RE: SSD-11802230 SYDNEY OLYMPIC PARK NEW HIGH SCHOOL SSDA RESPONSE TO SUBMISSIONS ON TRAFFIC

Table 1 Response to submissions on traffic and Transport

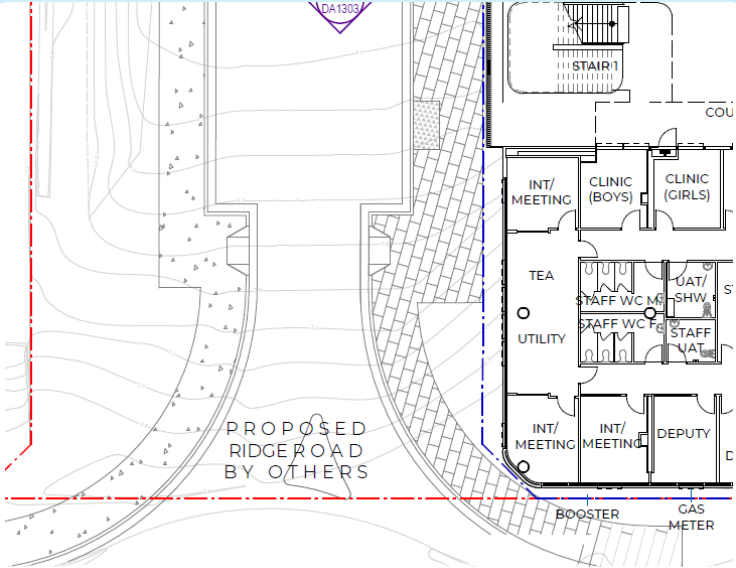
A 2.3	Demonstrate that the footpath width on Burroway Road adjacent to the roundabout and on site bicycle parking is sufficient to cater for the expected pedestrian demand and complies with relevant standards.	<p>School designs have been modified to be consistent with Development Consent DA 40-2015 as modified, in particular the approved Ridge Road. As a result of this, there are changes proposed to the concept layout, including a reconfiguration of the site.</p> <p>With the new design, the pinch point is eradicated because the site is now integrated with the Ridge Road design. Refer to below for an extract of the design and the interface with the footpath.</p>	Addendum

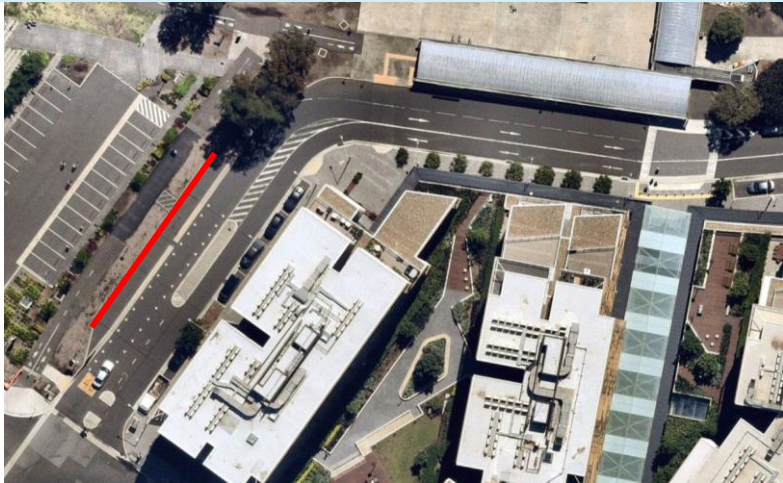
G 3	TfNSW is seeking approximate construction timelines and operational dates for Stage 1 and 2. It is understood that the delivery of Stage 2 of the subject development, is subject to financials but indicative timeframe should be provided.	The development as amended will be constructed in a single stage. However, approval is sought for only 850 students at this stage. Any future increase in student numbers will be subject to separate approvals.	Additional information
G 4	It is noted that the Transport Impact Statement states that “servicing and waste collection will occur along the future eastern road (delivered by others) with direct level on-street access to the storerooms. It is expected the eastern road will be completed prior to commencement of school operations. Waste collection is discussed in further detail at section 7.15 of	If the proposed road is not delivered in time for the opening of the school, the waste collection would occur on the frontage of the school at a Burroway Road loading zone, which could be provided outside of kiss 'n drop times (e.g. before 8 am, 9.30 am-2.30 pm and after 4 pm). Loading for any other purpose (e.g. deliveries) could use this same space. It is noted that this would be a temporary measure.	Additional information

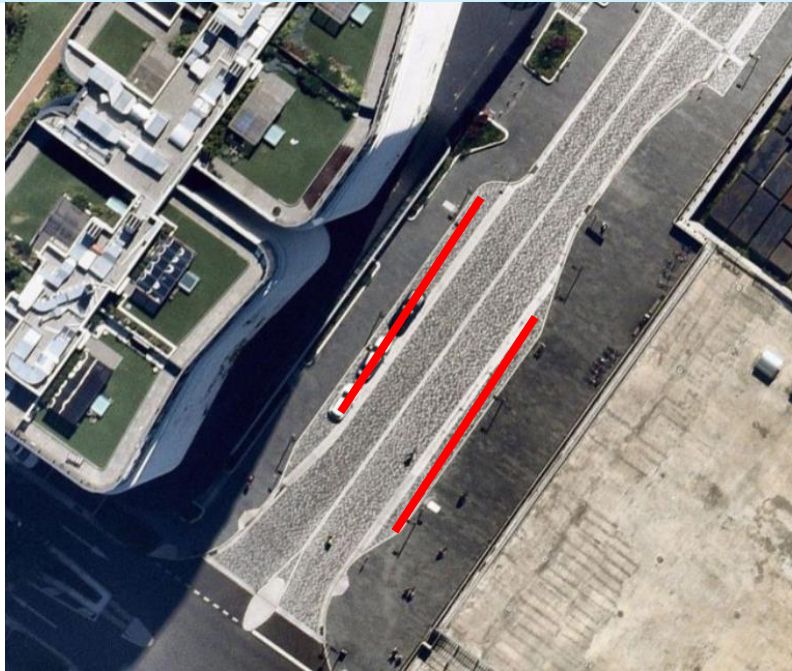
G 7	<p>Any proposed pedestrian crossings and facilities on the local road network will need to be considered by Council and the Sydney Olympic Park Authority via Council’s Local Traffic Committee.</p>	SINSW will comply with all necessary approval processes.	Additional information
G 8	<p>A significant number of vehicles and pedestrians will access the site at the start and end of the school day. School Zones must be installed along all roads with a direct access point (either pedestrian or vehicular) from the school. School Zones must not be provided along roads adjacent to the school without a direct access point. Road Safety precautions and parking zones should be incorporated into the neighbouring local road network:</p> <ul style="list-style-type: none"> – 40km/hr School Zones are to be installed in accordance with the following conditions. – Council should ensure that any parking, drop-off / pick-up zones and bus zones incorporated are in accordance with TfNSW standards. <p>TfNSW are responsible for speed management along all public roads within the state of New South Wales. That is, TfNSW is the only authorised organisation that can approve speed zoning changes and authorise</p>	SINSW will comply with all necessary approval processes.	Additional information
